Project	IEEE 802.16 Broadband Wireless Access Working Group < <a href="http://ieee802.org/16">http://ieee802.org/16</a> >
Title	Amendment to Subscriber Mode Management in Section 14.2.6
Date Submitted	2006-07-20
Source(s)	Jee Hyeon Na, ETRI, E-mail: <a href="mailto:jhna@etri.re.kr">jhna@etri.re.kr</a> Yun Won Chung, PhD, Soongsil University, E-mail: <a href="mailto:ywchung@ssu.ac.kr">ywchung@ssu.ac.kr</a> JungMo Moon, PhD, ETRI, E-mail: <a href="mailto:jmmoon@etri.re.kr">jmmoon@etri.re.kr</a> Mi-Young Yoon, ETRI, E-mail: <a href="mailto:myyun@etri.re.kr">myyun@etri.re.kr</a> Sang Ho Lee, PhD, ETRI, E-mail: <a href="mailto:leesh@etri.re.kr">leesh@etri.re.kr</a> Young Seok Kim, Samsung, E-mail: <a href="mailto:stephenk@samsung.com">stephenk@samsung.com</a>
Re:	Call for Comment on P802.16g Baseline Document
Abstract	This contribution proposes service primitives for accounting.
Purpose	The document should be considered during the resolution of comments on the baseline document.

## Amendment to Subscriber Mode Management in Section 14.2.6

Figure 493 Subscriber mode transition diagrams of MS & BS

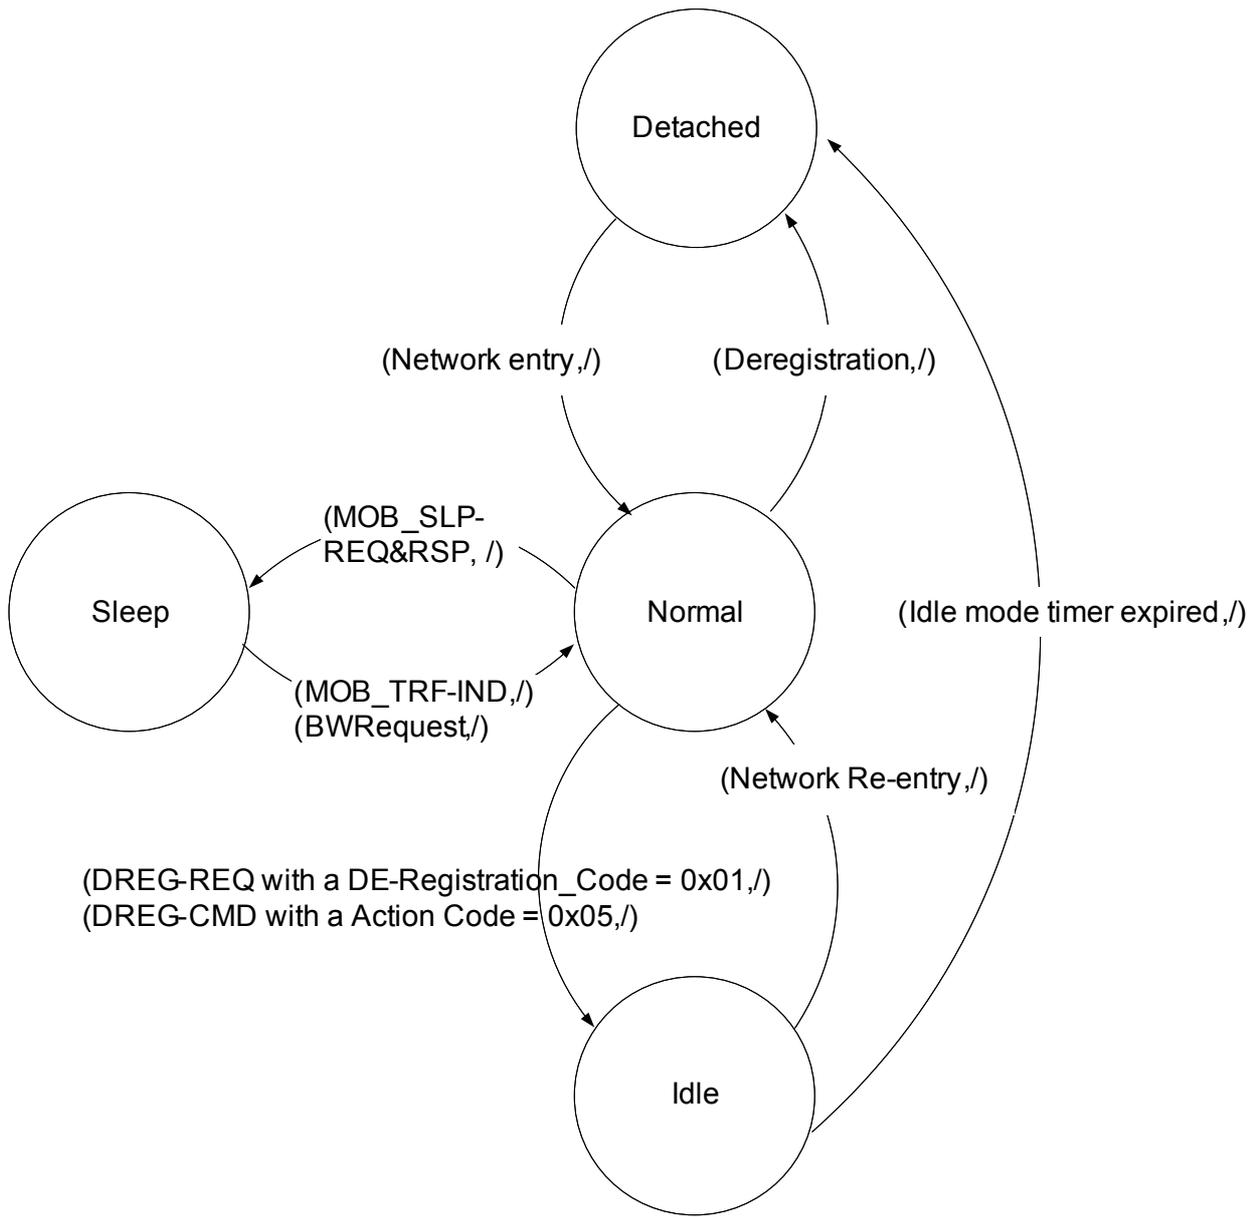
Figure 493 shows Subscriber Mode transition diagram at both an MS and a BS. Initially, the subscriber mode is Detached Mode and the subscriber mode at both an MS and a BS changes from

Detached Mode to Normal Mode after initial network entry procedure. Subscriber Mode ~~at both an MS and a BS~~ changes from Normal ~~Operation Mode~~ to Idle Mode when the MS issues an MS De-registration Request (DREG-REQ) message with De-Registration\_Request\_Code=0x01 or the BS issues a De-register Command (DREG-CMD) message with Action Code = 0x05. Then, the MS stays at Idle Mode and updates its location when the paging group changes. The Subscriber Mode returns back to Normal ~~Operation Mode~~ from Idle Mode after completing ~~n~~Network re-entry. Transition from Normal ~~Operation Mode~~ to Sleep Mode is performed after an MS successfully exchanges Sleep Request (MOB\_SLP-REQ) and Sleep Response (MOB\_SLP-RSP) messages with a BS. If there is any DL traffic toward an MS from a BS, MOB\_TRF-IND is broadcast to the MS from the BS and Subscriber Mode of the MS and the BS changes from Sleep Mode to Normal ~~Operation Mode~~. If there is any UL traffic from an MS, Bandwidth Request (BW Request) is sent to the serving BS from the MS and Subscriber Mode of the MS and the BS changes from Sleep Mode to Normal ~~Operation~~, too. Transition to Detached Mode from Normal Mode occurs when the MS sends DREG-REQ message without Deregistration\_Code=0x01 or receive DREG-CMD without Action Code = 0x05. Transition to Detached Mode from Idle Mode ~~occurs~~ occurs when the Idle Mode Timer of the MS is expired.

If MS is switched off in any of Normal, Idle, and Sleep Modes, the state moves to Detached Mode.

Editorial note: IP address release not addressed yet.

Figure 494 Subscriber mode transition diagrams of NCMS

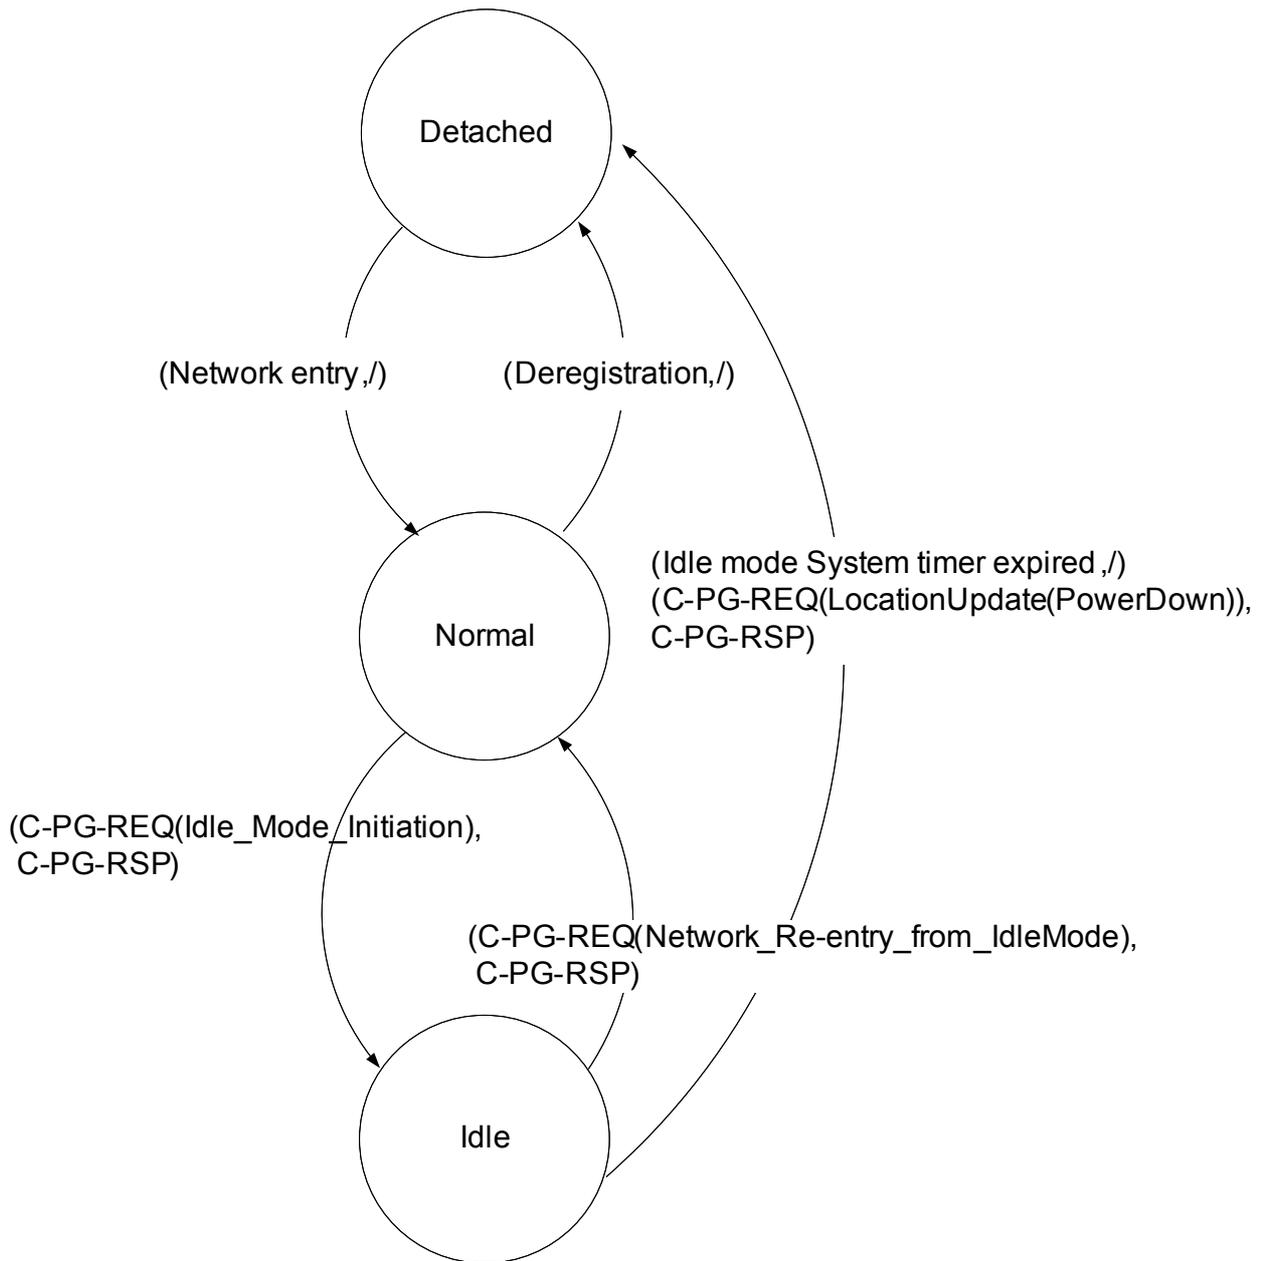
Figure 494 shows Subscriber Mode transition diagram at the NCMS with service primitives related with the Subscriber Mode transition. Initially, the subscriber mode is Detached Mode and the subscriber mode at NCMS changes from Detached Mode to Normal Mode after initial network entry procedure of MS. Subscriber Mode transition from Normal ~~Operation Mode~~ to Idle Mode is performed by exchanging C-PG-REQ and C-PG-RSP between a BS and the NCMS after successful DREG-REQ message with De-Registration\_Request\_Code=0x01 or DREG-CMD message with Action Code = 0x05 between an MS and a BS, where C-PG-REQ and C-PG-RSP are defined in 14.2.6.2.1 and 14.2.6.2.2, respectively. Subscriber Mode transition from Idle Mode to Normal ~~Operation Mode~~ is initiated after exchanging C-PGNOTFY, C-PG-RSP, and C-PG-ACK between a BS and the NCMS, where C-PG-NOTFY, C-PG-RSP, and C-PG-ACK are defined in 14.2.6.2.4, 14.2.6.2.2, and 14.2.6.2.3, respectively. Transition to Detached Mode from Normal Mode occurs by exchanging C-PG-REQ and C-PG-RSP between a BS and the NCMS after successful DREG-REQ message without De-Registration\_Request\_Code=0x01 or DREG-CMD message without Action Code = 0x05 between an MS and a BS. Transition to Detached Mode from Idle Mode occurs when the Idle Mode System Timer is expired. If MS is switched off in either Normal or Idle Mode, the state moves to Detached Mode.
